**HORIZONTAL DIRECTIONAL DRILL ANALYSIS
WALTONVILLE ROAD CROSSING
PADEP SECTION 105 PERMIT NO.: E22-617
PA-DA-0056.0000-RD
(SPLP HDD No. S3-0080-16)**

The 16-inch pipeline HDD is referred to herein as HDD S3-0080-16.

ORIGINAL HORIZONTAL DIRECTIONAL DRILL DESIGN SUMMARY: 16-INCH

HORIZONTAL DIRECTIONAL DRILL REDESIGN

Figure 2A. Revised 16-Inch HDD Plan and Profile

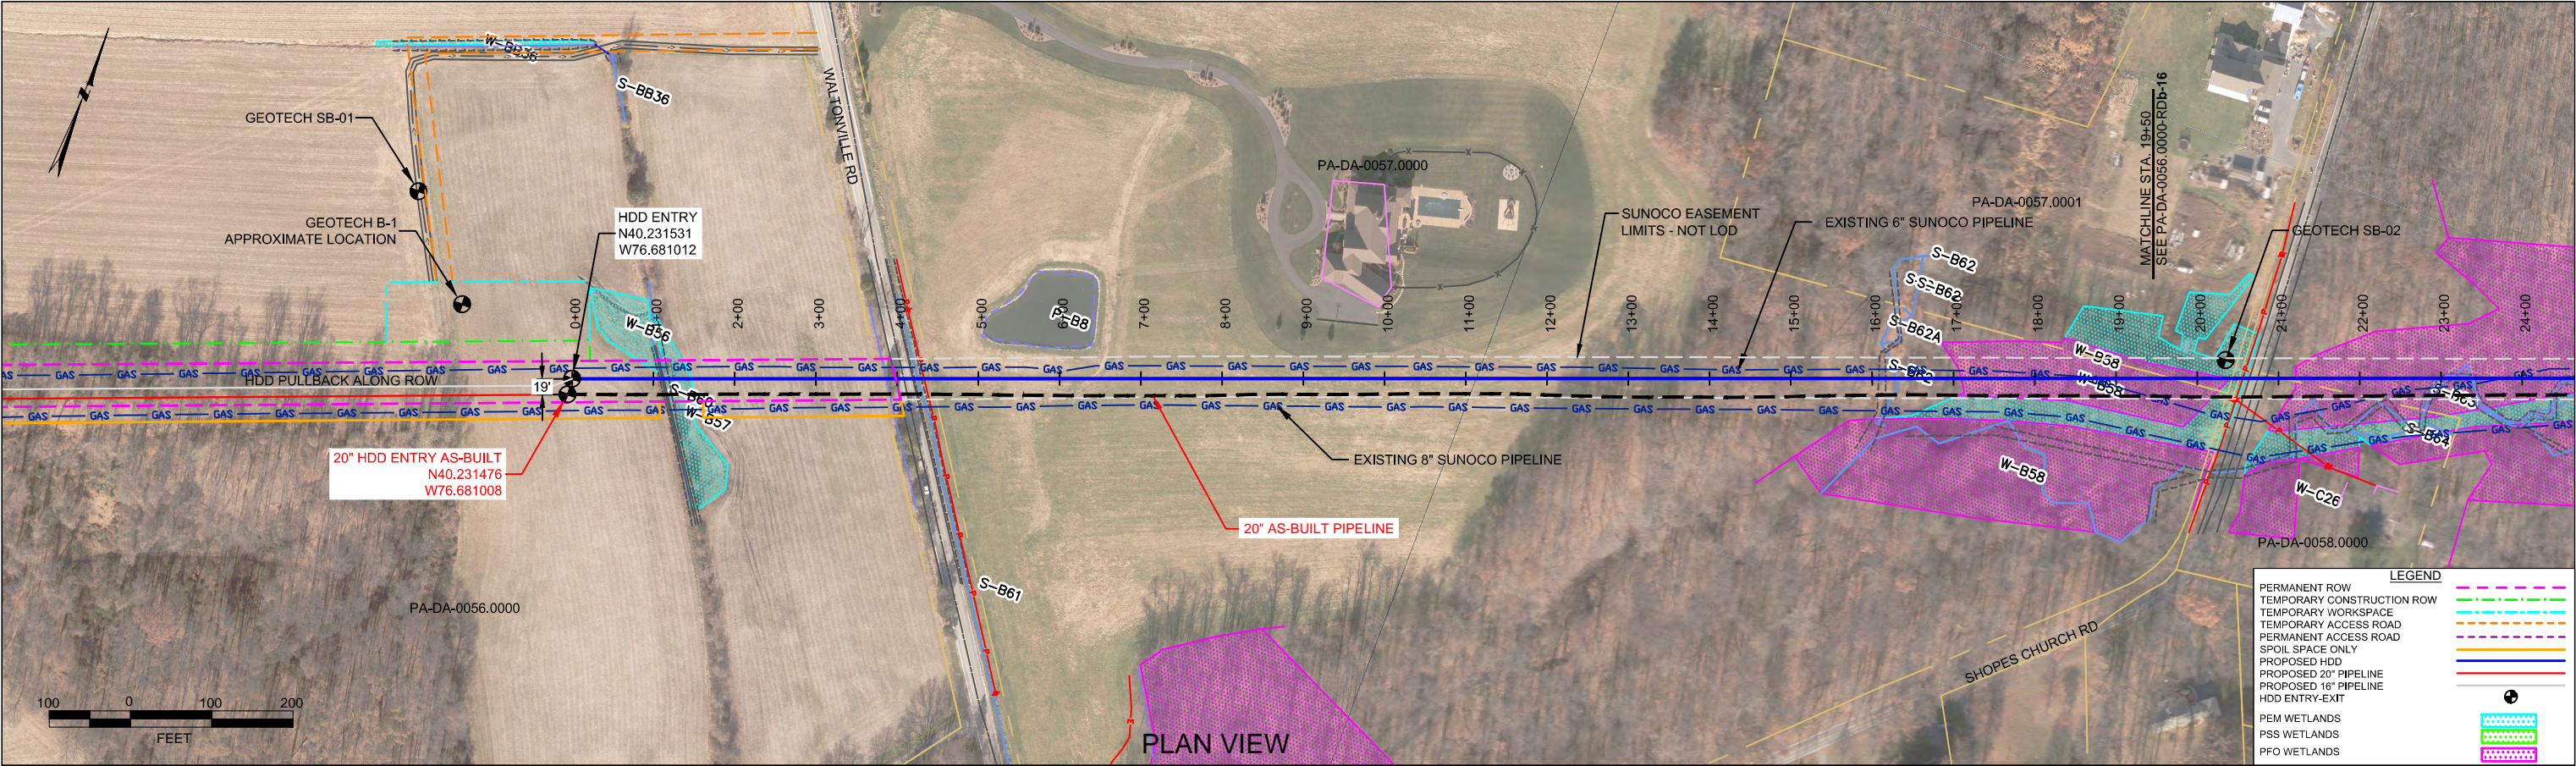
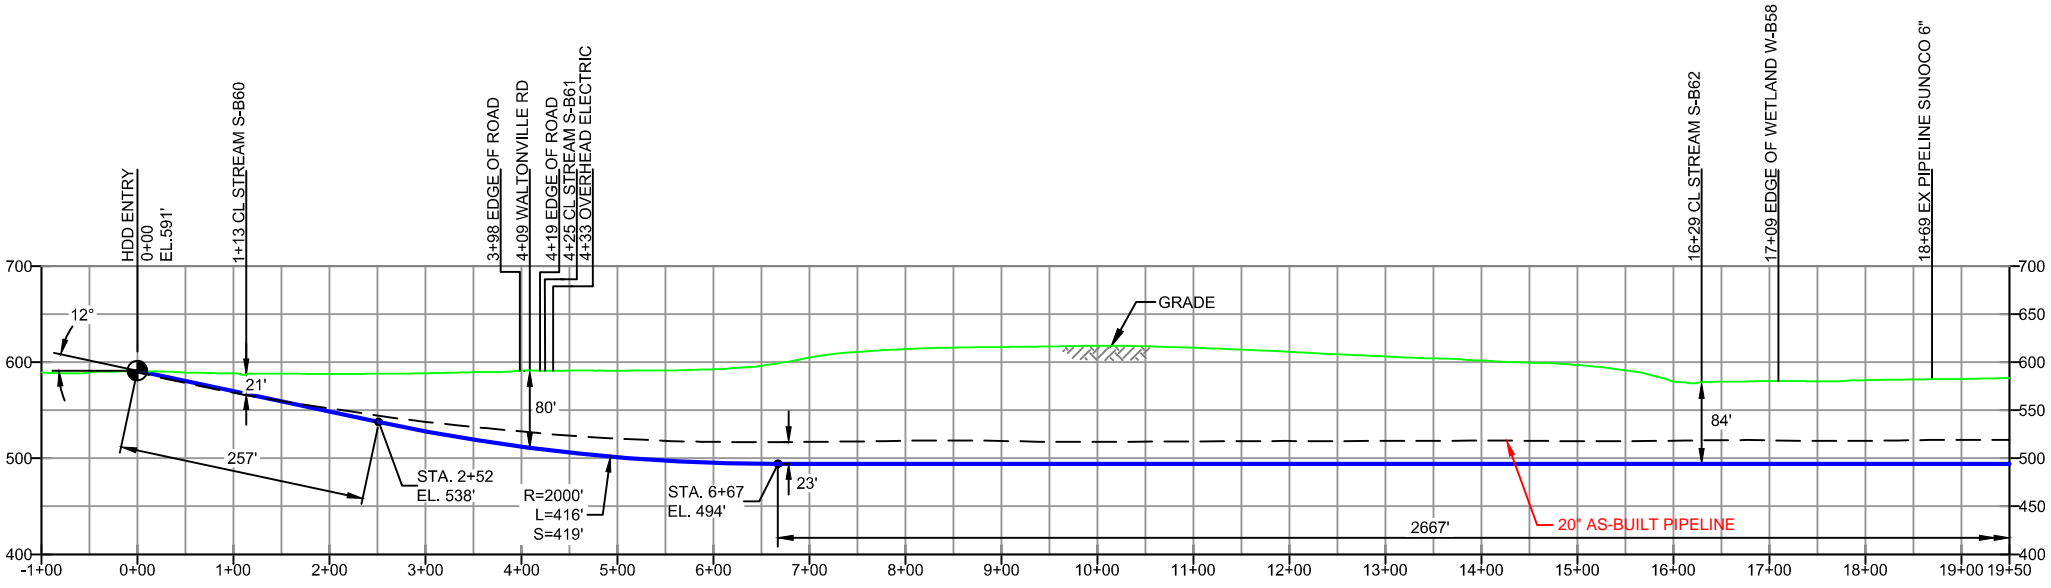
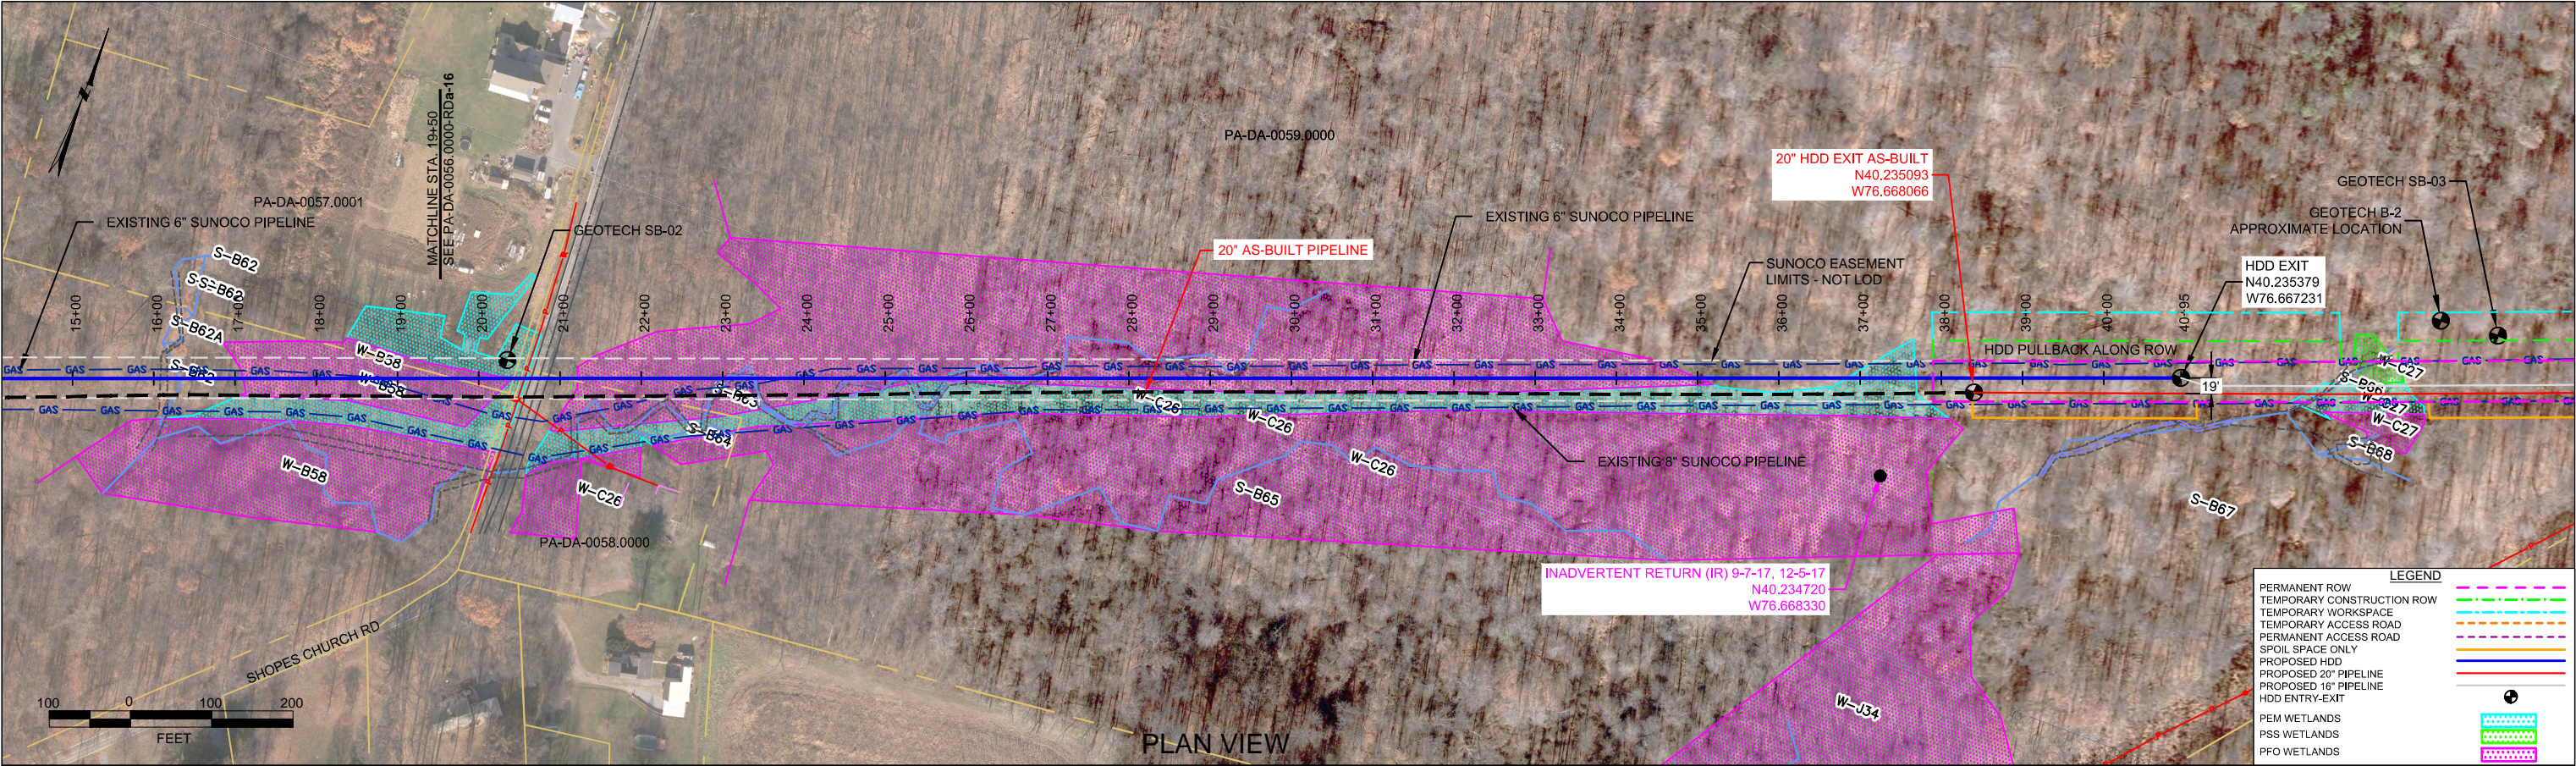
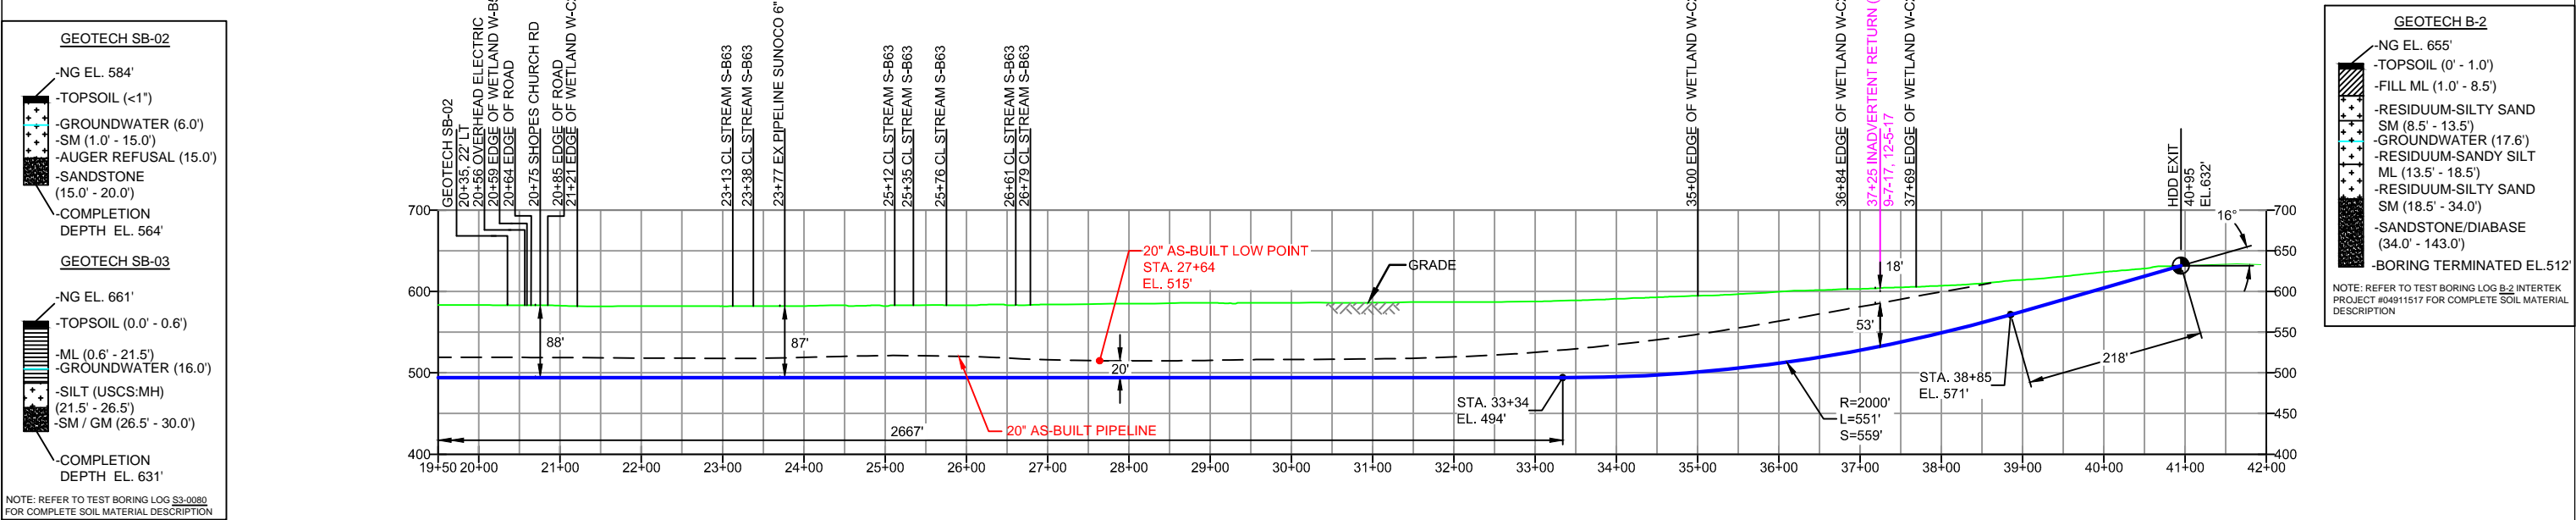
Punch out IRs are difficult to prevent. Regardless, SPLP drilling specialists have modified the profile for the 16-inch pipeline to increase the depth of profile, and increase the angles of entry and exit to reduce the potential for IR events during the drilling phases for completion of the second pipeline installation.

SHEET 14	TO	SHEET 15	AERIAL SITE PLAN	EP3	DESIGN CHANGE - EXTENDED DRILL AND UPDATED GEOTECH INFORMATION		MRS	12/07/18	RMB			12/07/18	AMC	12/07/18		
						EP2	REVISED PER PADEP COMMENTS RECEIVED 09-06-16		MRS	10/07/16	RMB			10/07/16	AAW	10/07/16		
						EP1	REVISED PER PADEP COMMENTS		DLM	05/09/16	RMB	05/09/16	AAW	05/09/16				
						EP			JTW	03/15/16	RMB	03/15/16	AAW	03/15/16				
						B	ADDED GEOTECH INFO		MRS	09/22/15	RMB	09/22/15	AAW	09/22/15				
	DWG NO		DWG NO	DESCRIPTION	NO.	DESCRIPTION		BY	DATE	CHK	DATE	APP	DATE	SCALE: 1"=200'		DWG. NO: PA-DA-0056.0000-RDa-16

SHEET 14	TO	SHEET 15	AERIAL SITE PLAN																																																																																																																														
				DWG NO		DWG NO	DESCRIPTION																																																																																																																														
EP4	DESIGN CHANGE - INCREASED DRILL EXIT ANGLE	MRS	02/13/19	RMB	02/13/19	AMC	02/13/19																																																																																																																														
EP3	DESIGN CHANGE - EXTENDED DRILL AND UPDATED GEOTECH INFORMATION	MRS	12/07/18	RMB	12/07/18	AMC	12/07/18																																																																																																																														
EP2	REVISED PER PADEP COMMENTS RECEIVED 09-06-16	MRS	10/07/16	RMB	10/07/16	AAW	10/07/16
